Millstone Nuclear Power Station, Unit No. 2
Resolution of Open Items
Amendment 89 to DPR-65

Millstone Nuclear Power Station, Unit No. 2

Resolution of Open Items

Confirmation of Sleeve Plugging Limit

Figure
 4.3-2

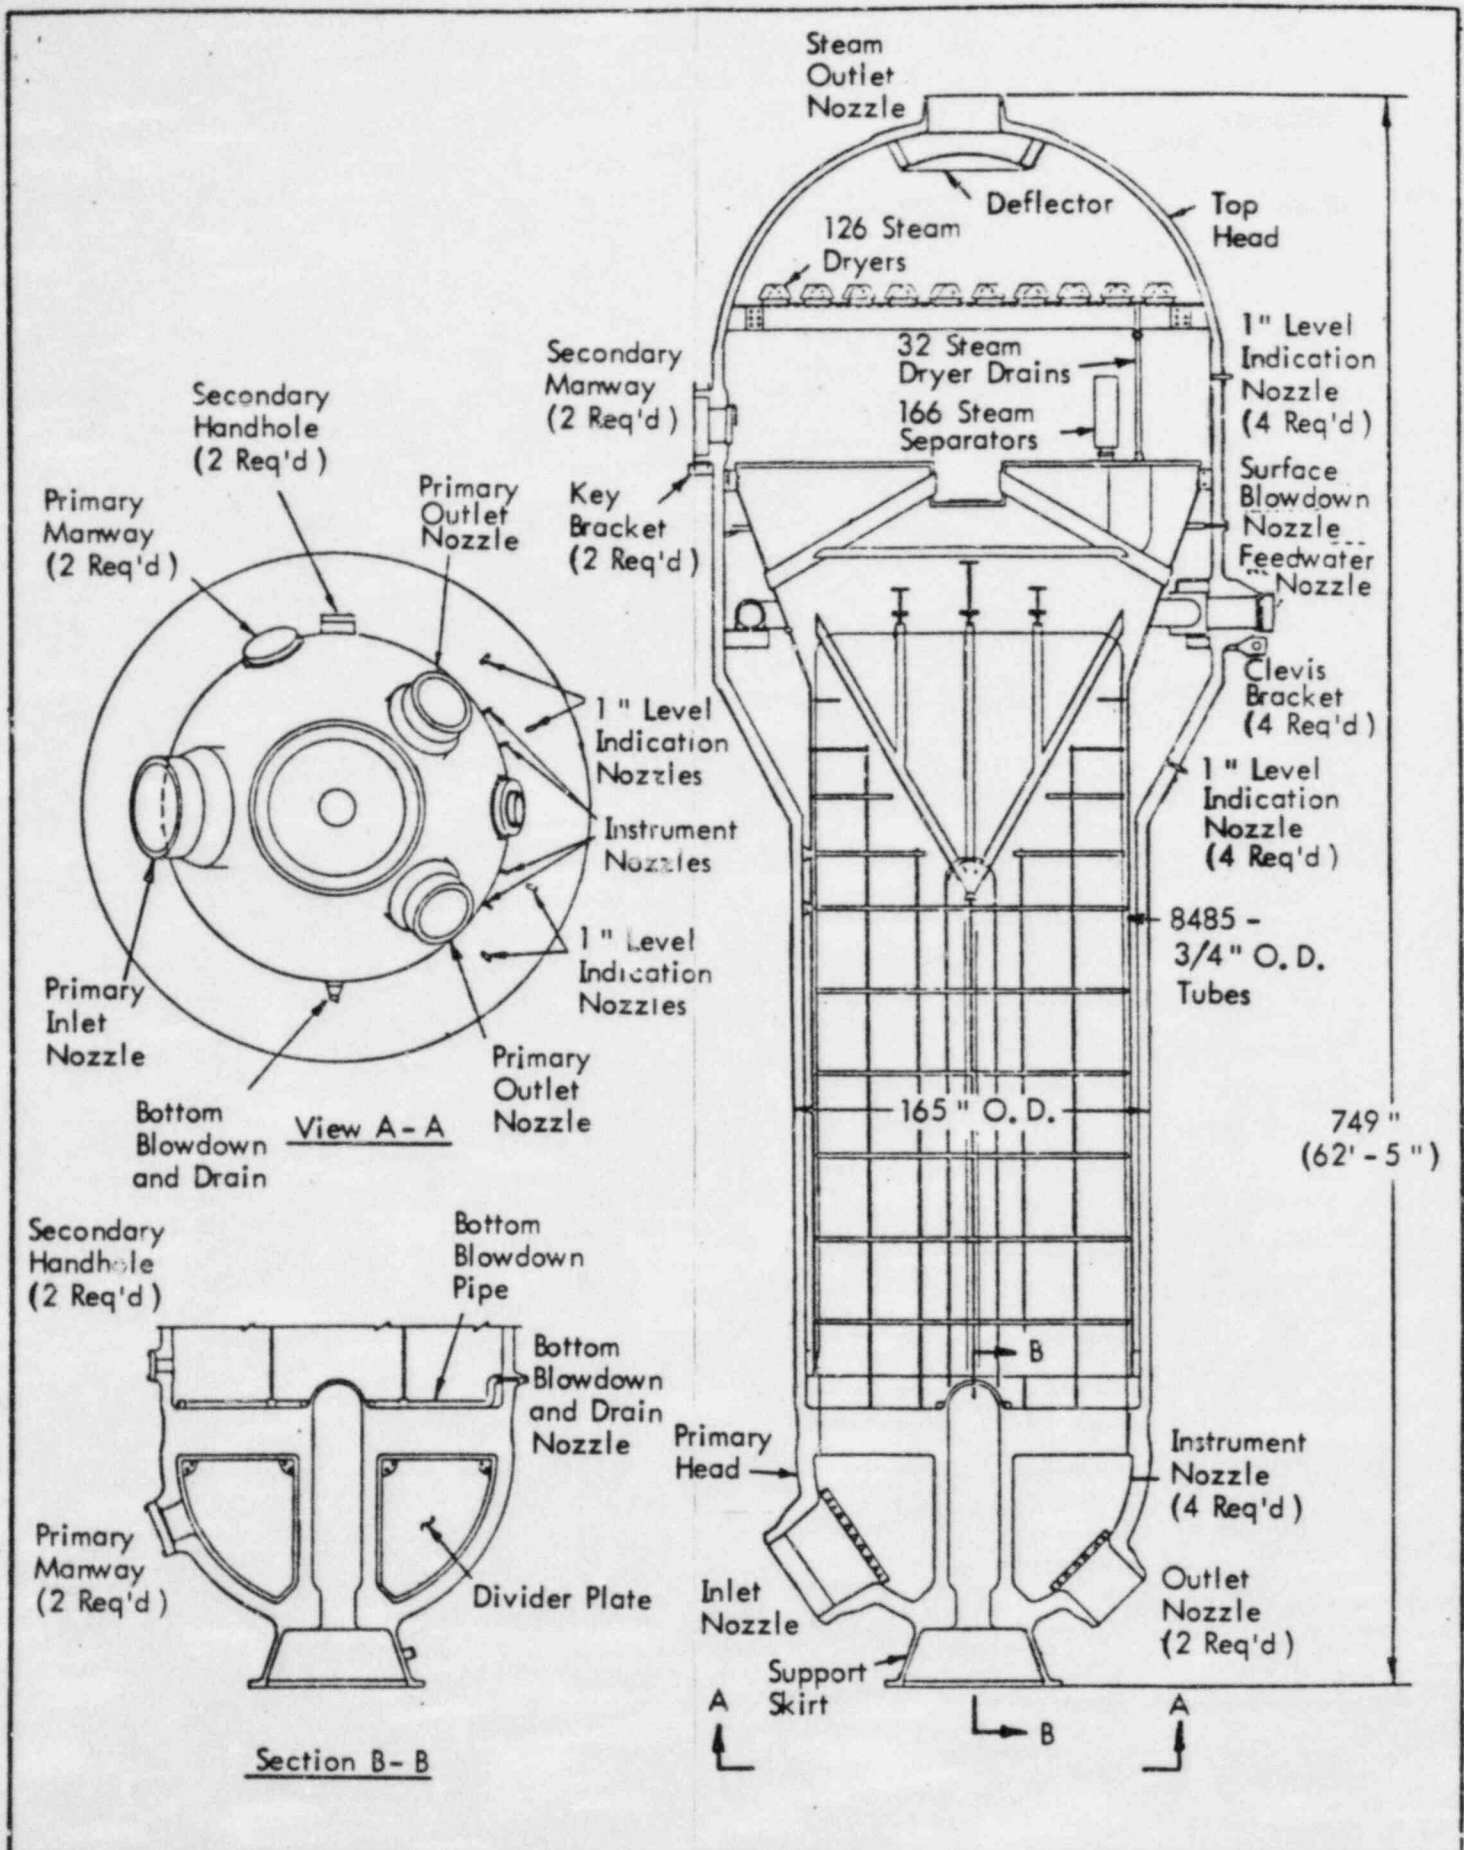
Millstone Unit No. 2 employs a Combustion Engineering design nuclear steam supply system. Each of the two steam generators contain 8519 tubes in a U-bend configuration. The tubes are arranged in a triangular pitch. The tube sheet is 21.5 inches thick and 14 feet in diameter. Since the pressure is normally higher on the primary side of the tube sheet than on the secondary side, the tube sheet becomes concave upward. The tube sheet flexes further during a main steamline break due to the larger pressure differential between the primary and secondary sides of the steam generator. Design features have been incorporated into the steam generator to limit the tube sheet deflection. The most notable feature of the Millstone Unit No. 2 steam generator design is the stay cylinder depicted in Figure 4.3-2 of the FSAR included herein.
